# Access Compliance Report

## Public Rights-of-Way (Curb Ramps)

Intersection ID: N/A	Main Street: INDEPENDENCE_RD	Cross Street: N/A	Location: SW
ADA ID: A9E6F32D1C7C	Ramp Type: Directional1	Initial Pass/Fail: Fail	Overall Compliance: No
		Severity Score: 21.25

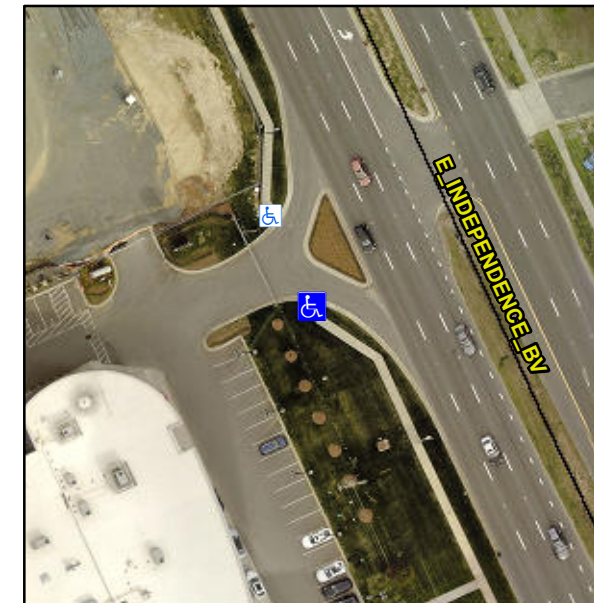
**R304.5.1, R304.2.2**

Compliance	Description	Data	Compliance	Description	Data
N/A	Ramp Length (in)	91.0	N/A	Grade Break?	N/A
No	Ramp Width (in)	47.5	N/A	Grade Break Slope (%)	0.0
No	Ramp Slope (%)	8.8	N/A	Grade Break XSlope (%)	0.0
Yes	Ramp XSlope (%)	1.9			
N/A	Flare Type LT	N/A	N/A	Flare Type RT	N/A
N/A	Flare Slope LT (%)	N/A	N/A	Flare Slope RT (%)	0.0
N/A	Flare Traversable LT?	N/A	N/A	Flare Traversable RT?	N/A
N/A	Landing Length (in)	0.0	N/A	DWS Provided?	N/A
N/A	Landing Width (in)	0.0	N/A	DWS Contrast?	N/A
N/A	Landing Slope (%)	0.0	N/A	DWS Length (in)	N/A
N/A	Landing X Slope (%)	0.0	N/A	DWS Full Width?	N/A
N/A	Landing Curb? (Y/N)	N/A	N/A	DWS Offset LT (in)	N/A
N/A	Shared Landing?	N/A	N/A	DWS Offset RT (in)	N/A
N/A	Gutter Ponding?	0.0	N/A	Gutter Slope (%)	N/A
N/A	Gutter Lip Ht (in)	0.0	N/A	Gutter X Slope (%)	N/A
N/A	Painted X Walk1?	No		Road Slope (%)	4.3
	X Walk 1 Direction	To N		Road X Slope (%)	5.3
	X Walk 1 Width (in)	N/A		Clear Space?	N/A

**Remove & Replace Entire Ramp.**
